Re: FCC ID OV5-VCA10001
Applicant: John Deere Special Technologies
Correspondence Reference Number: 13156
731 Confirmation Number: EA96765
Date of Original E-Mail: 03/30/2000

DATE: 12-Apr-00
TO: Joel Schneider
CC: Ron Stahlhut, William Coopman
FROM: Bill Crook
SUBJECT: Bell 212A Modem Occupied Bandwidth Measurement

CVDM-2000 - CW MODE (NJICVDM-2000)

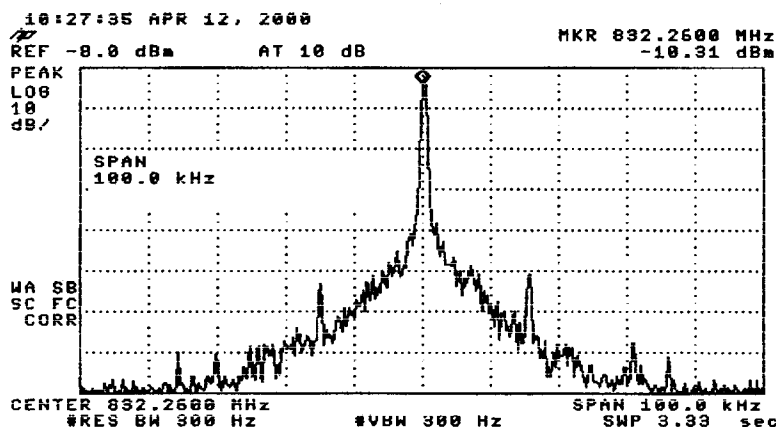
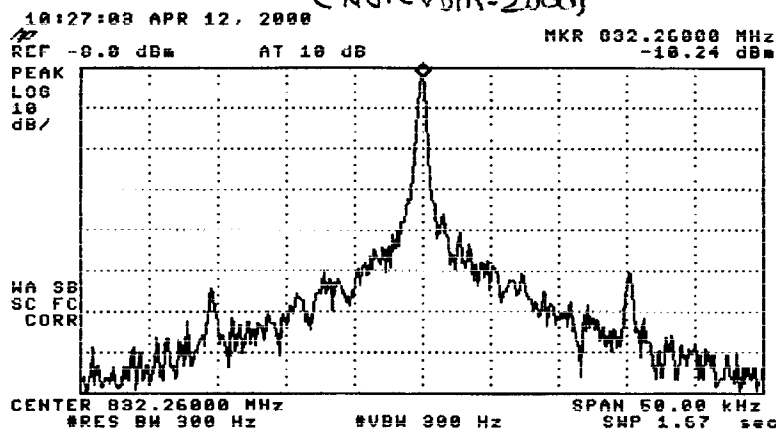
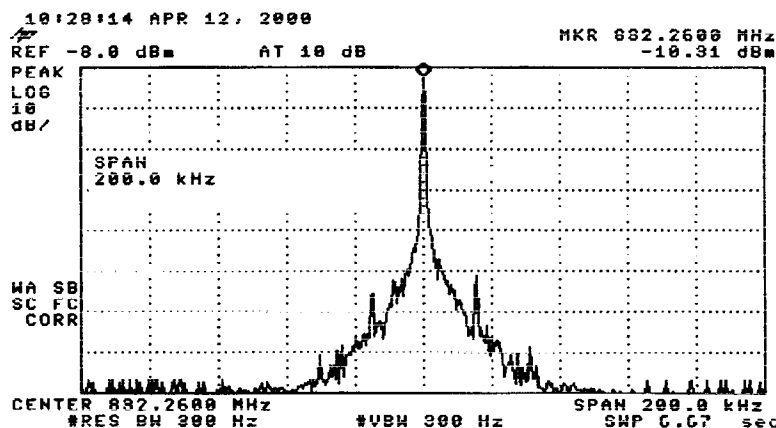
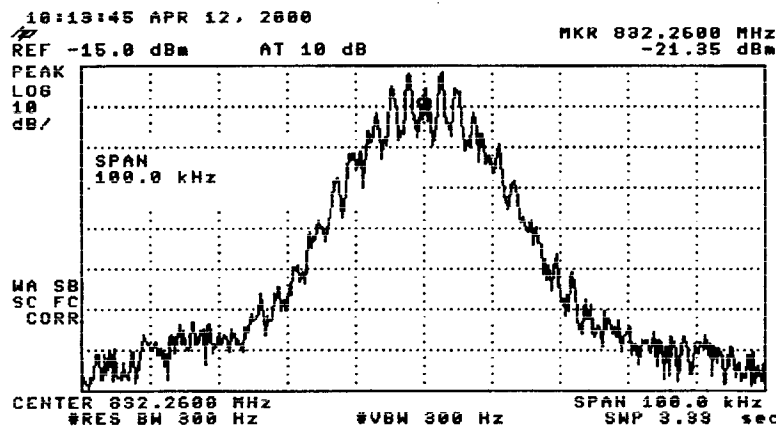
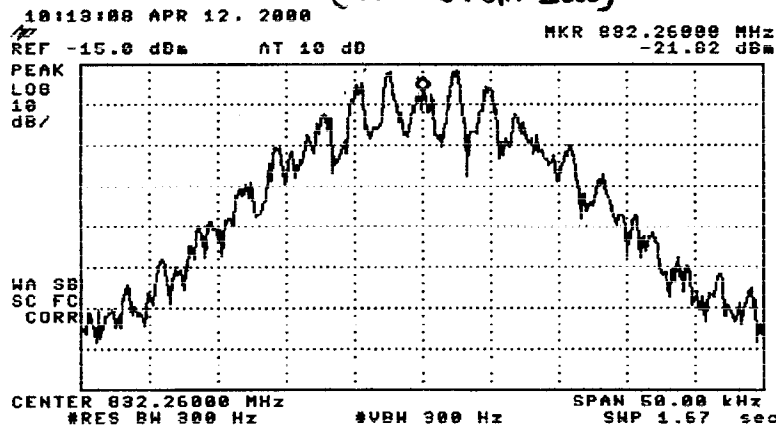
The first page contains spectral plots of the CVDM-2000 in CW mode (3 different spans), which is provided to you as a reference. During the data session, the cell site commanded the CVDM-2000 to channel 242 and PLC5 (+16 dBm) so, I manually commanded the unit to the same channel (ch 242) and power level (PLC5) for the CW

CVDM-2000 - Bell 212A, 1200 Baud, DPSK MODEM (NJICVDM-2000)

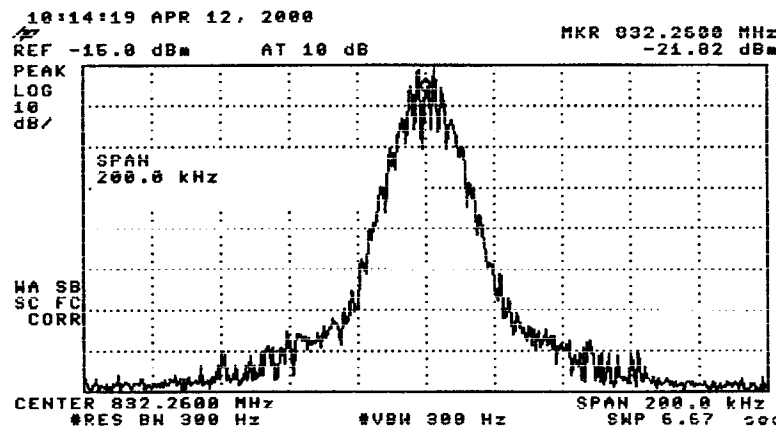
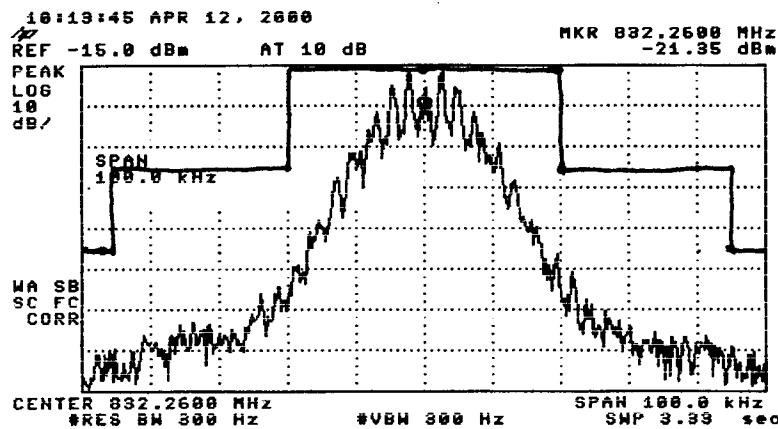
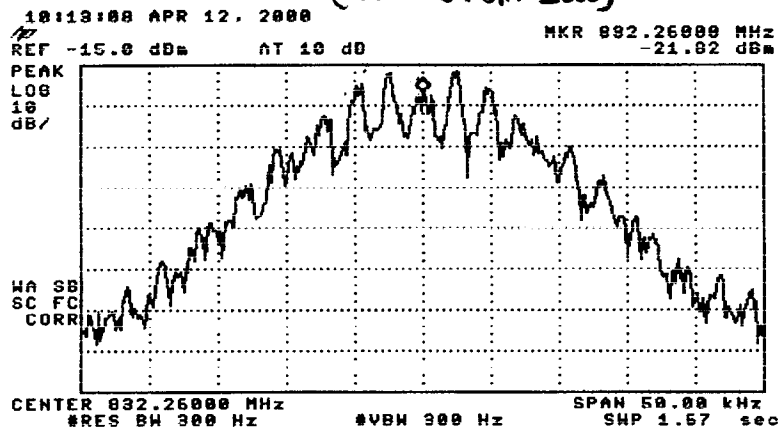
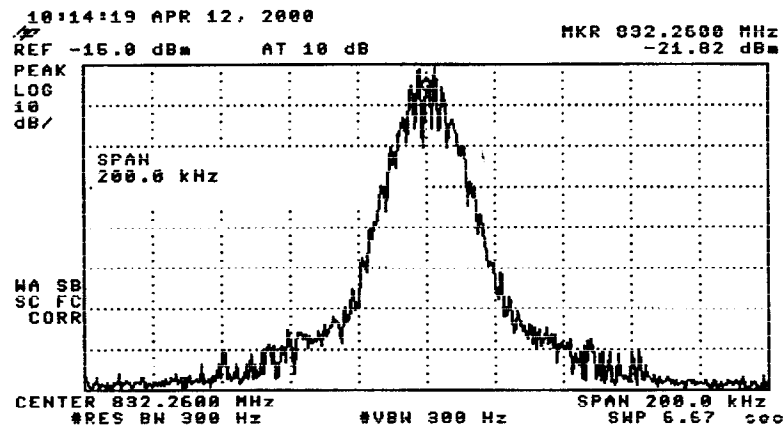
The grant can only reflect the actual capability of the device. The voice specification will be deleted. The specification 40K0F1D must be justified or corrected.
40K0F1D represents a signal with a necessary bandwidth of 40 khz , FM modulation and data.
You need to supply the necessary bandwidth calculation (2M+2D) for the 1200 baud signal. Where M is the maximum modulation frequency and D is the maximum deviation. This should be consistent with the plot of the emission.
The emission designator must be corrected accordingly.

You also requested a Carson's Rule estimation of the occupied bandwidth. The modulation frequency is 1.2 kHz and the peak deviation is about 2.5 kHz. Therefore, the estimated bandwidth is $2(1.2 + 2.5) = 7.4$ kHz.

Susan, please change the emission designator to 7k4f1d. Attach occupied bw measurements from Bill Crook, along with graphs, and paper graph with emission mask drawn on it. Include new pictures of test setups from W0208. Include data sheets for W0208 Run 3.
